Bulletin No. 152_New_Modem

November 15, 2006

OfficeServ 500, OfficeServ 100 and OfficeServ 7400 New Modem Card

OfficeServ 500 Modem Card

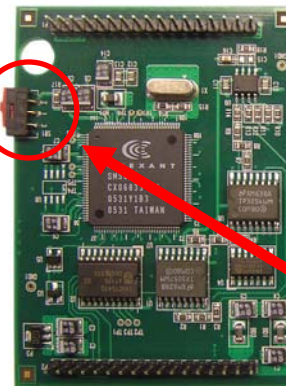
This new modem card complies with the new ROHS import regulation regarding removal of lead in manufacturing process. The new circuit pack has stenciled on the card "OfficeServ 500 Modem Rev 1.0". The original modem card has stenciled on the card "iDCS 500 Modem Rev. 1.0".

New Switch
must be set for
T1 for use in the
United States.
